**Project: IEEE P802.15 Working Group for Wireless Personal Area Networks (WPANs)**

**Submission Title:** [DS-UWB Responses to MB-OFDM-Voter NO Comments]

**Abstract:** [Response to NO voter comments and feedback regarding the DS-UWB (Merger #2) Proposal]

# Complexity Estimates

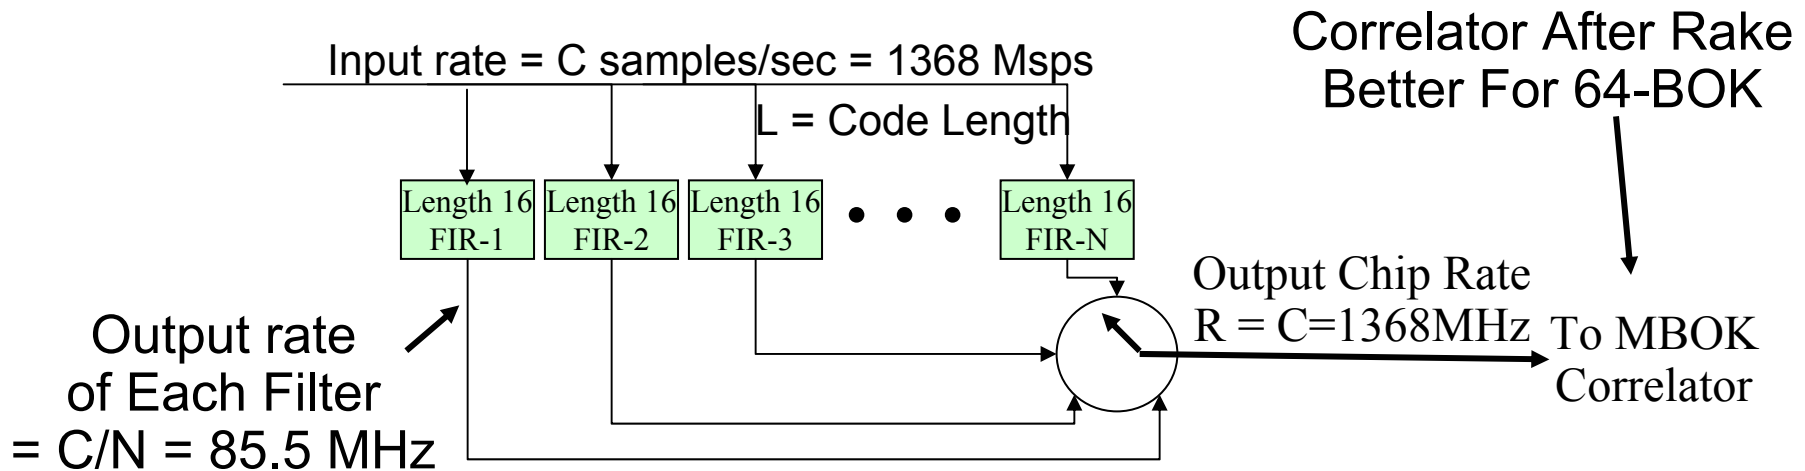
(a) Please provide a complete complexity analysis for the reference receiver used to generate the system performance results. When providing digital gate count, also specify the clock frequency that is assumed.

Component	16-Finger Architecture (03/449r0 Estimate) <b>PREVIOUS PROPOSAL</b>	DS-UWB 16-Finger Rake Architecture <b>IMPROVED PROPOSAL</b>	DS-UWB 32-Finger Rake Architecture <b>IMPROVED PROPOSAL</b>
Matched filter [rake]	205K	26K	45K
Viterbi decoder	108K	54K	54K
Reed-Solomon decoder	20K	Not needed	Not needed
MBOK demodulator	61K	Not needed	Not needed
Synchronization	177K	30K	30K
Channel estimation	24K	24K	24K
Other Miscellaneous including RAM	30K	30K	30K
Equalizer	Not used	20K	20K
Total gates @ 85.5 MHz	604K	<b>184K</b>	<b>203K</b>

# Improved Proposal Is Based On 2 Parallel Branches, 3-bit A/D, Symbol Rate Output

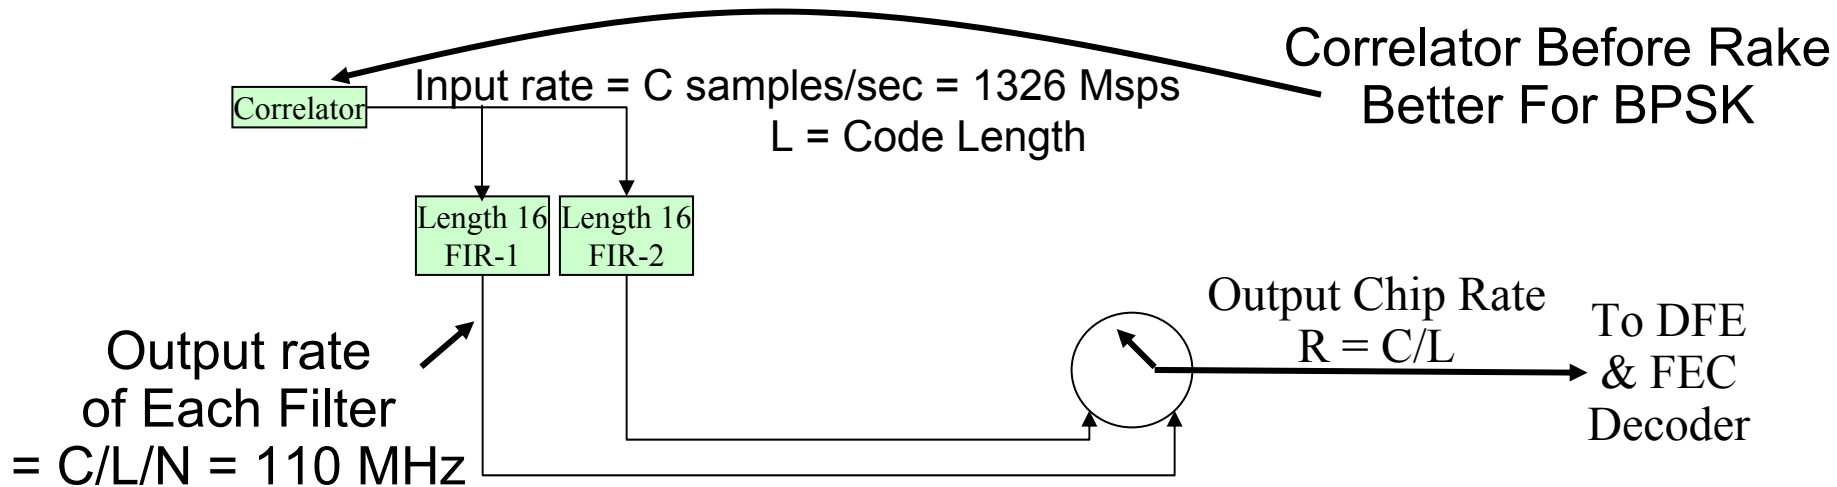
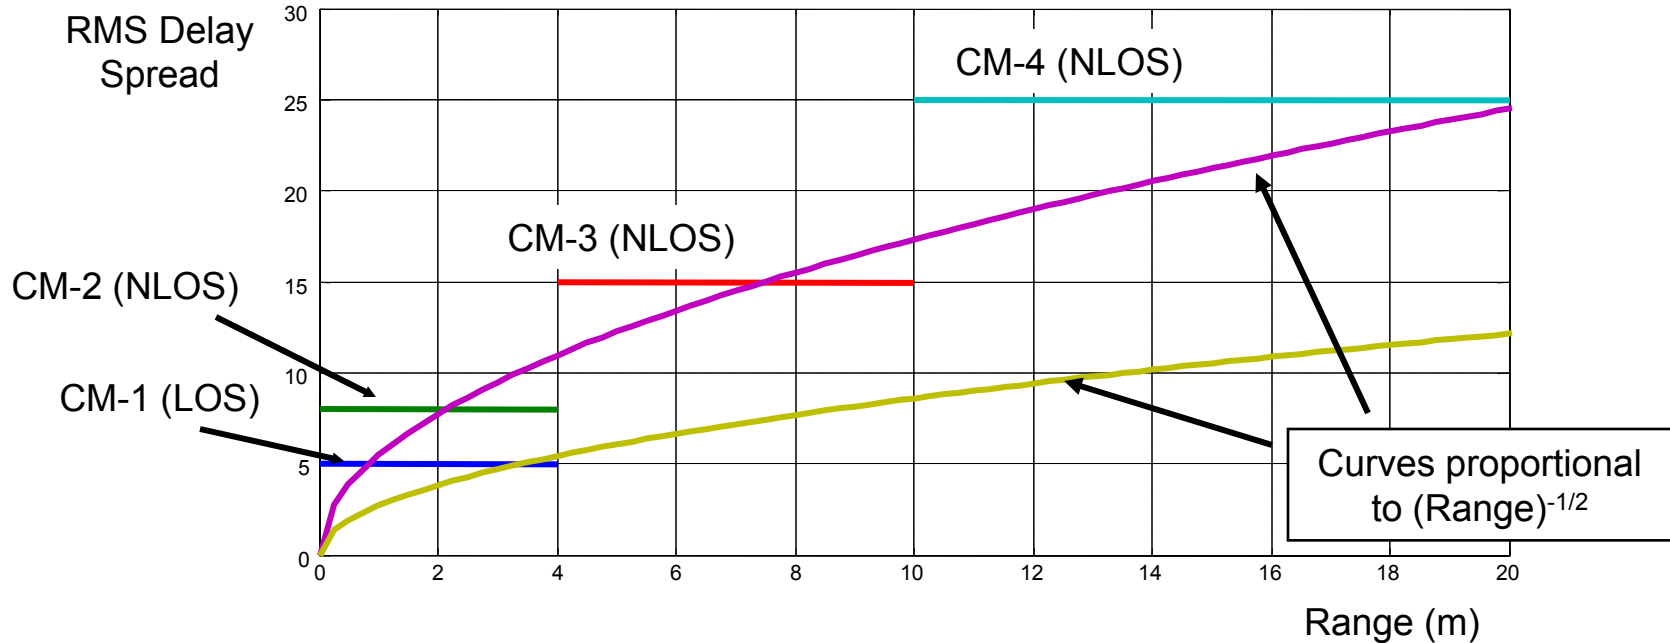
- Gate count reduction is due to
  - Moving of code correlator prior to rake
    - Code correlator (only requires adders) reduces processing rate to symbol rate prior to CMF or rake processing
  - Output rate is  $L$  times lower ( $L$ = code length)
    - Reduces output rate by the code length
  - Replace 64-BOK with 2-BOK (BPSK)
- A/D Is 3 bits, not 4 bits

Parallel N=2 filters so each can run slower by a factor of 2  
 $1326/L/2 = 1326/6/2 = 110 \text{ MHz}$

Complexity = (16 multipliers) \* (N=2 branches) \* (400 gates per 3-bit mult) \* (110 MHz)

= 26k Gates (including adders and overhead)

# Moderate RFI

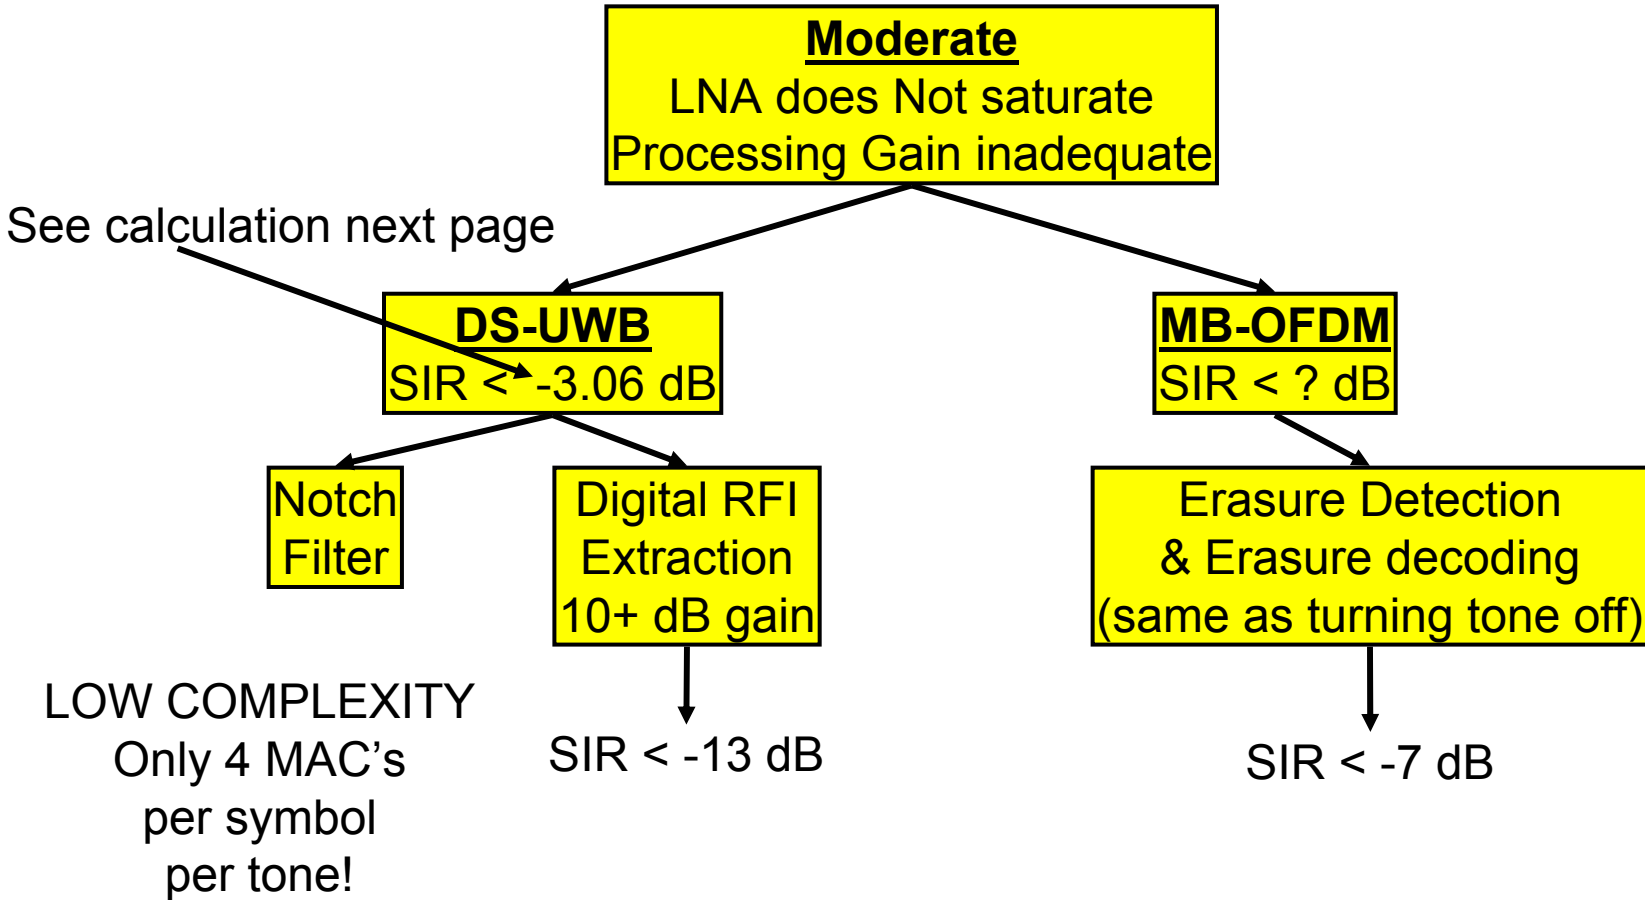
- (c) **Robustness to Narrow-band Interferers:** Document 15-03-0449-03-003a also demonstrates that the MBOK system does not meet the requirements of the selection criteria document in its ability to handle narrow band interferers. It is shown to be about 10 dB worse than the MB-OFDM system. The MBOK proposal claims that narrow-band interference rejection is performed using an external tunable notch filter. Can you provide details on the mechanism to detect a narrow-band interferer, the effectiveness and complexity of the detection circuitry and the loss in performance due to inserting a tunable notch filter at the receiver? Is the insertion loss due to the tunable notch filter also considered for all the other performance results?

- DS-UWB receivers with 3-bit ADC architectures
  - Simulations with no active NBI compensation indicate about 3 dB I-to-S is to be expected
  - Simple analysis with NO ACTIVE COMPENSATION (worst case):

- Required Eb/No is 5.0 dB for rate-½ FEC code
    - Assume 1.5 dB implementation loss (based on simulation results)
    - Total noise-per-bit is  $-87 \text{ dBm} = -174 \text{ dBm/Hz} + 10 \log(110 \text{ MHz}) + (6.6 \text{ dB NF})$

- Sensitivity =  $-87 + 5 + 1.5 = -80.5 \text{ dBm}$
    - Sensitivity + 6dB (per spec) = signal power (S) =  $-74.5 \text{ dBm}$
    - Allowable (I+N) =  $-74.5 - 5.0 - 1.5 = -81 \text{ dBm}$  (assume I is noise-like at slicer)

- Allowable I is therefore  $10 \cdot \log(10^{(-81/10)} - 10^{(-87/10)}) = -82.24 \text{ dBm}$
    - At 110 Mbps, processing gain is 12:1 over (I+N) in signal bandwidth → 10.8 dB gain (worst case)

- Processing gain is a function of tone frequency – depends on pulse shape. At band edges, gain is much higher
    - Allowable I-to-S is therefore  $-81.24 + 10.8 - (-74.5) = \mathbf{3.06 \text{ dB I-to-S}}$

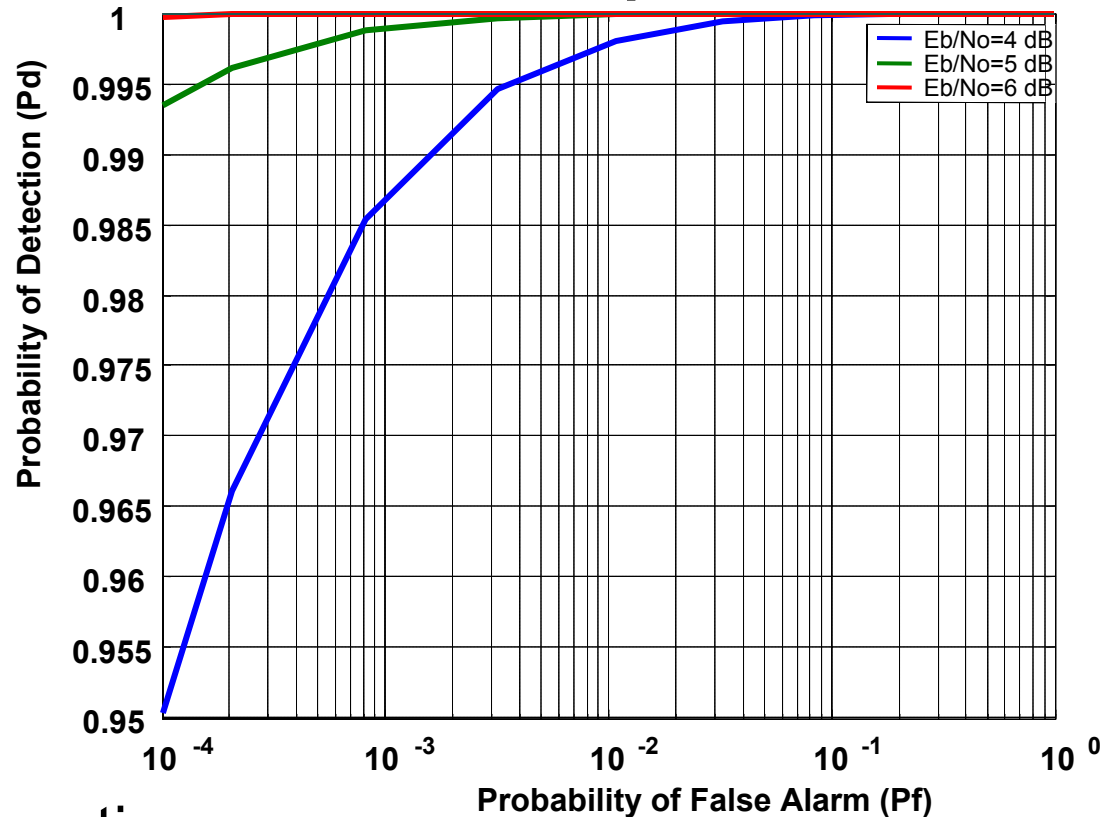
A RS code is used as a concatenated code for data rates of 112 Mbps, 200 Mbps, 224 Mbps and 448 Mbps. The use of a concatenated code results in latency due to the need to receive the entire code word before decoding/de-interleaving and the latency of the decoder operation. For instance, a latency of two code words at a data rate of 112 Mbps corresponds to ~8 microseconds. However, the SIFS time specified in the MBOK proposal is 5 microseconds. How is it possible to meet the SIFS time, if a concatenated code is used?

Reed-Solomon codes are no longer a part of the DS-UWB proposal.
